APB5 - Replacing the Cell Block Module on High-Voltage Battery (Recall Campaign)

Vehicle Type: **Taycan (Y1A / Y1B / Y1C)**

Model Year: **As of 2020 up to 2024**

Concerns: **Cell block module**

Installation position: Cell block module

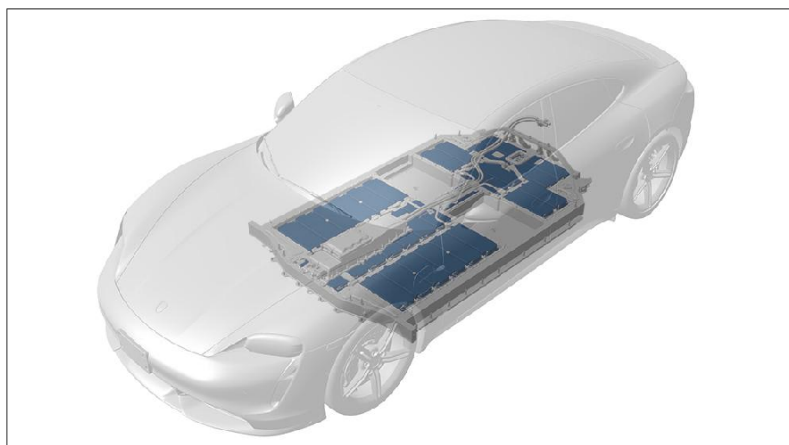
Cause: **There is a possibility that, under certain circumstances, a defect in the battery cells installed in the high-voltage battery can occur on the affected vehicles.**

In this case, a short circuit within the battery modules during the vehicle's service life cannot be ruled out, which could lead to thermal events and later to a fire in the vehicle.

Action: Replace cell block module.
